# UNITED STATES PATENT AND TRADEMARK OFFICE

APPLICATION NO.	FILING DATE	FIRST NAMED INVENTOR	ATTORNEY DOCKET NO.	CONFIRMATION NO.
10/826,073	04/16/2004	Paul A. Lindberg	83714.86249	9970
24335 7590 08/19/2008 WARNER NORCROSS & JUDD LLP 900 FIFTH THIRD CENTER 111 LYON STREET, N.W. GRAND RAPIDS, MI 49503-2487				
			EXAMINER	
			CHIN, PAUL T	
		ART UNIT	PAPER NUMBER	
		3652		
		MAIL DATE	DELIVERY MODE	
		08/19/2008		PAPER

### Office Action Summary

## **DETAILED ACTION**

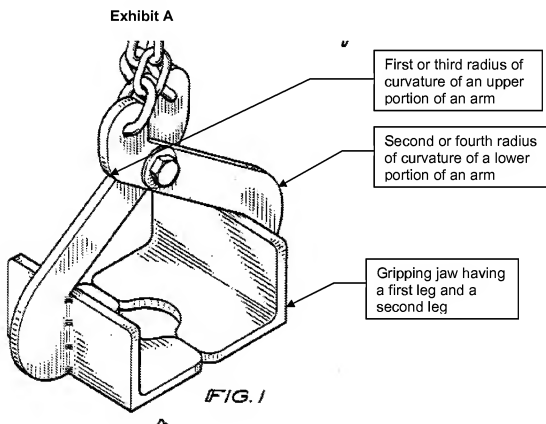
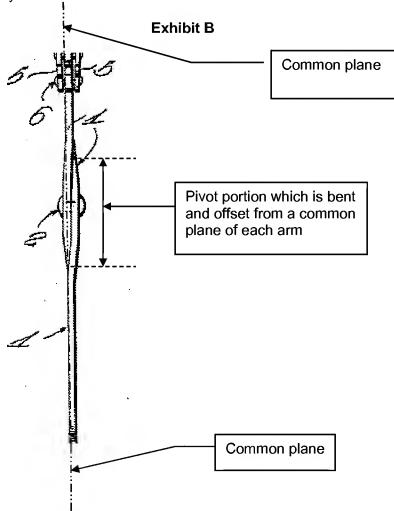
generally uniform thickness (see Fig. 3); wherein at least a portion of said upper portion of said first arm follows a first radius of curvature (see **Exhibit A**) having a center on an exterior side of said first arm; further comprising a first jaw affixed to said first arm, said jaw extending substantially perpendicularly to a longitudinal extent of said first arm, wherein said jaw includes a radius of curvature having a center on an interior side of said first arm; and wherein said jaw having a first leg and a second leg.

Fig. 3 of Kifer (Des. 245,972) shows that the first and second arms are aligned side by side, but does not clearly show that at least one of said pivot portion of said first arm and said pivot portion of said second arm is offset from said common plane. However, Hendrickson (1,480,820) teaches a gripping tongs having a pair of crossed levers or arms (1, 1) being pivoted at a pivot (2) wherein the pivot portions of each arm is bent and offset as shown in Fig. 2 (see **Exhibit B**) to restrict or limit the pivoting range of the

arms, to minimize the bending force, and also provide an effective grip by aligning the arms. Thus, it would have been obvious to those skilled in the art to modify the pivoting portion of the arm of Kifer's device (Des. 245,972) to be bent and offset as taught by Hendrickson (1,480,820) not only to limit the pivoting ranges of the arms but also to minimize the bending force of the arms providing better alignment and preventing the vertically rotation of the device.
